Reference: Omaha Department of Veterans Affairs TRIGA Reactor  
Docket N. 50-131, Facility License No. R-57

Subject: Revision of TRIGA Reactor SER and Technical  
Specifications

SAFETY EVALUATION REPORT  
NUREG-0988

Revision to Safety Evaluation Report  
of the Omaha V.A. Medical Center  
Research Reactor  
Docket No. 50-131

FIG. 7.1 BLOCK DIAGRAM OF INSTRUMENTATION

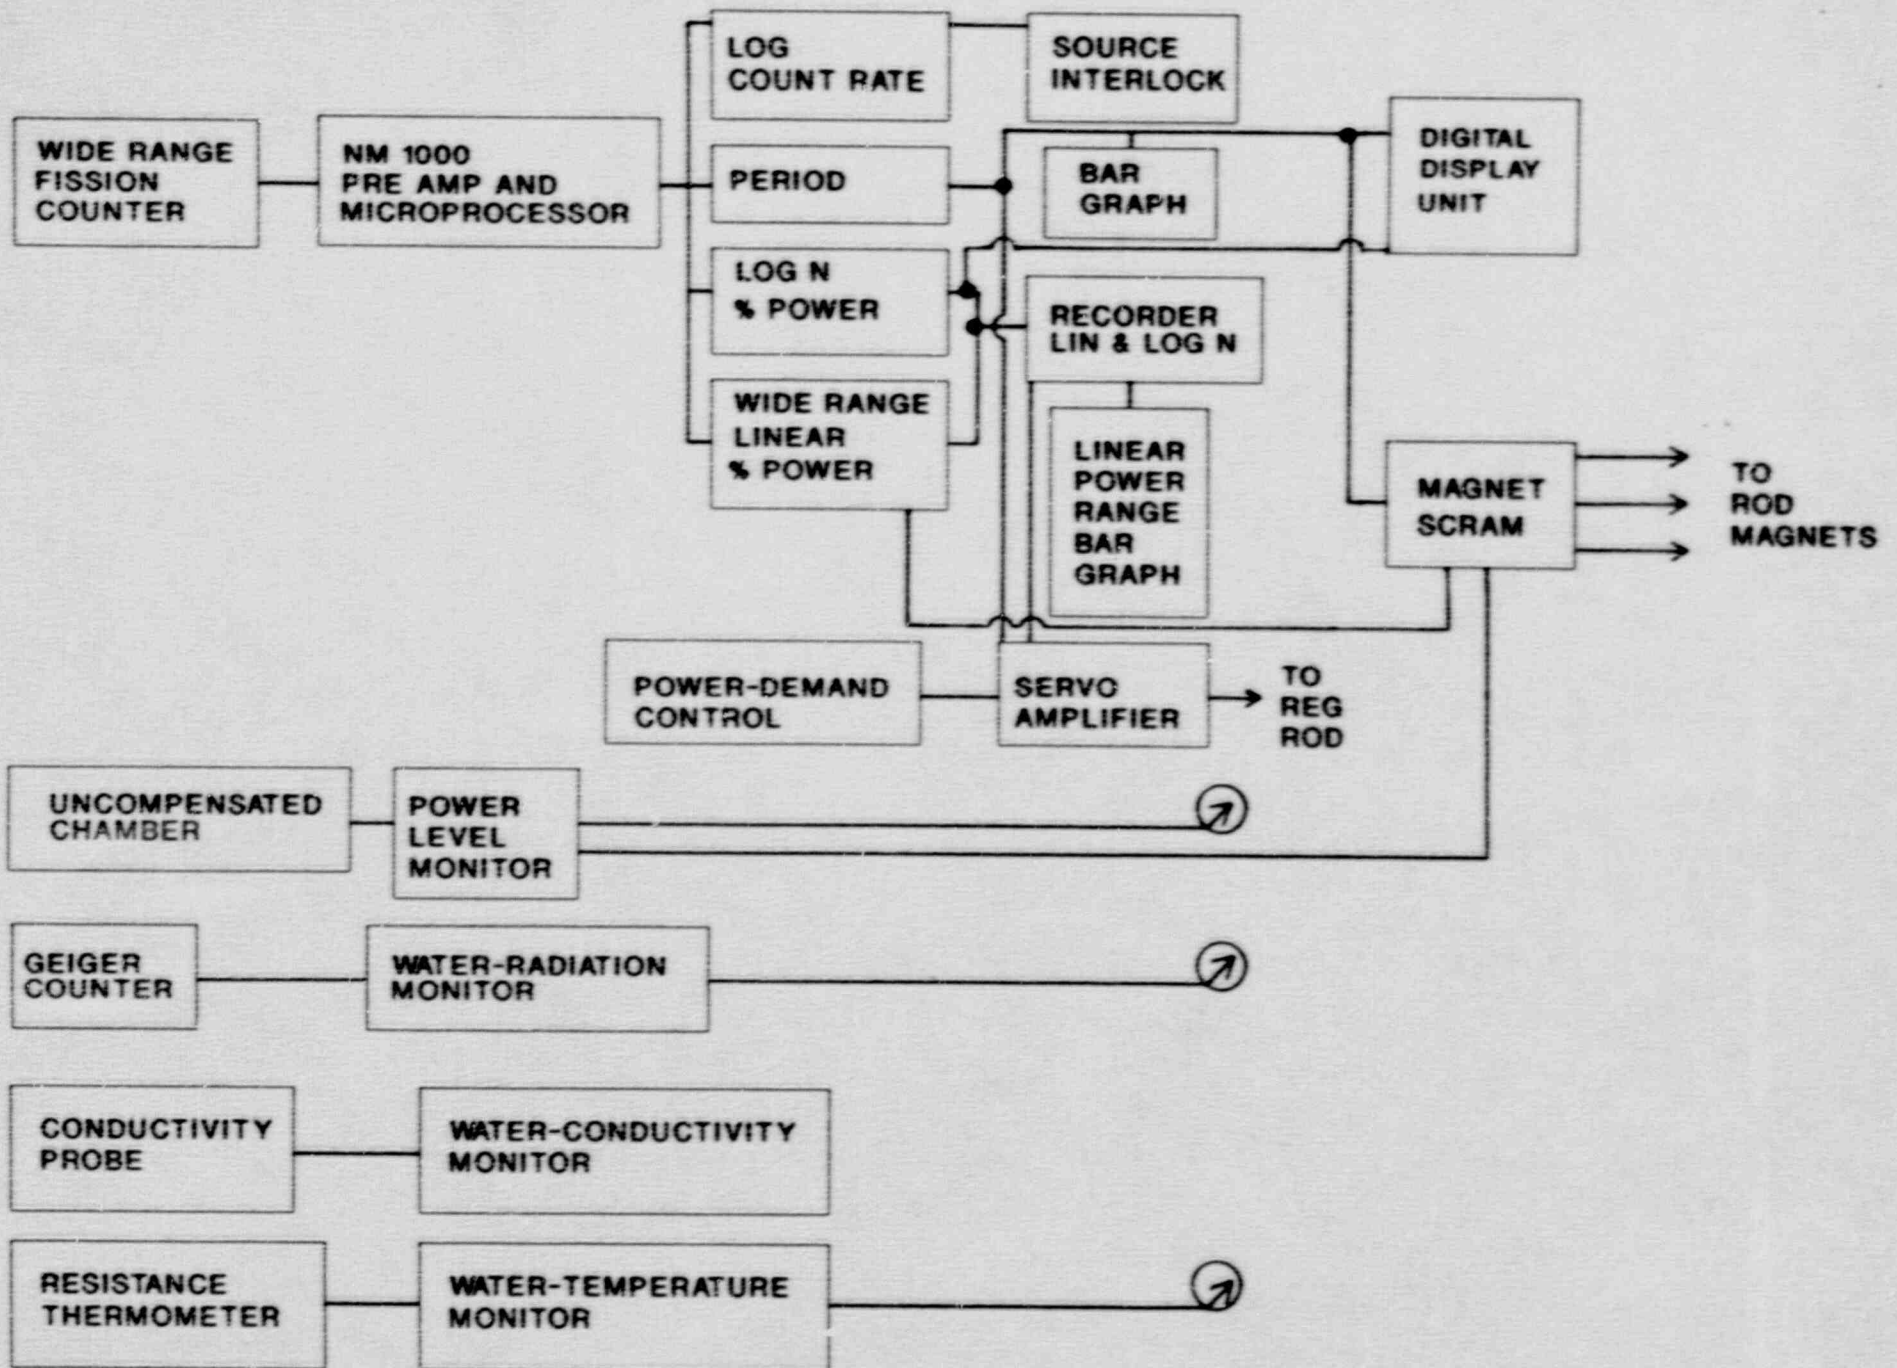
II. Remove the existing Figure 7.1 and replace with the attached Figures 7.1, 7.2 & 7.3.

This instrumentation provides the operator with the necessary information for proper manipulation of the nuclear controls (Figure 7.1 & 7.2).

FIG. 7.3 SCHEMATIC REPRESENTATION OF CONDITIONS LEADING TO A SCRAM  
ON THE TRIGA MARK I REACTOR

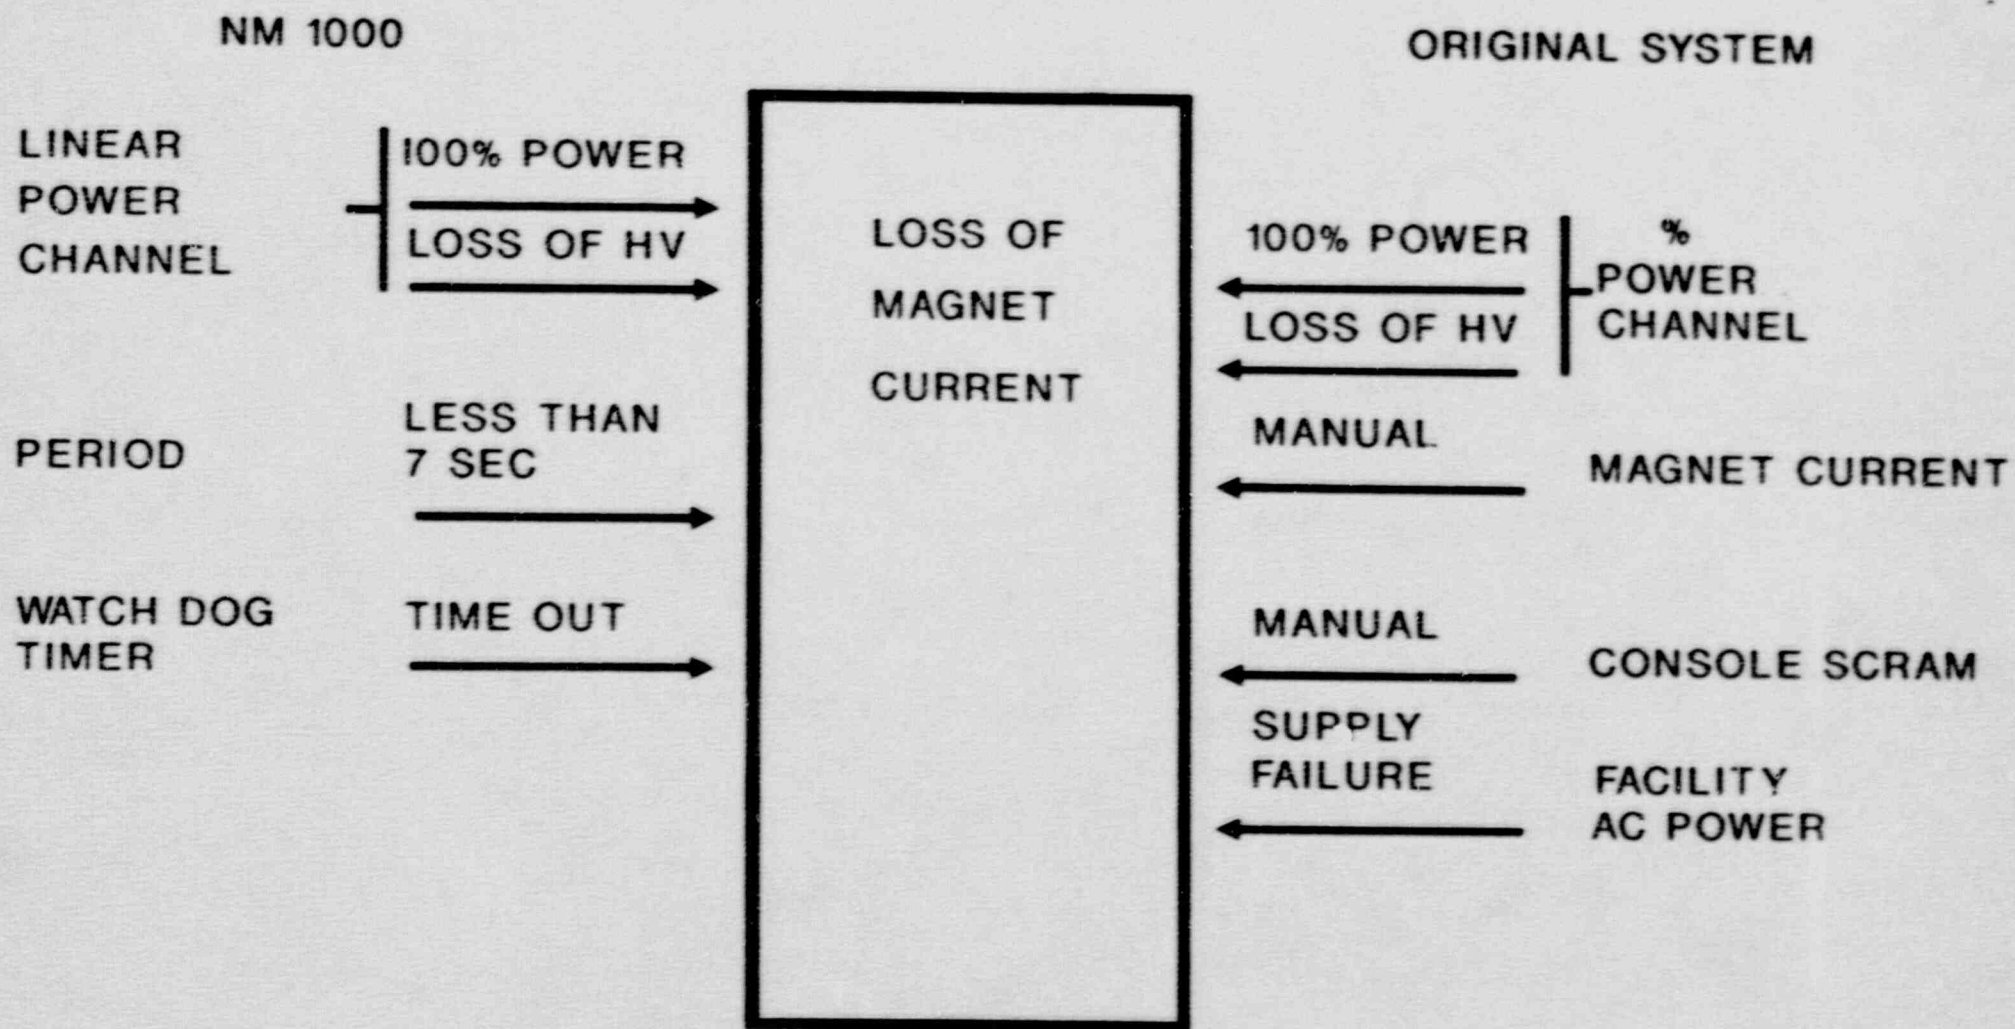
A schematic representation of conditions leading to a scram on the TRIGA Mark I reactor is shown in Figure 7.3
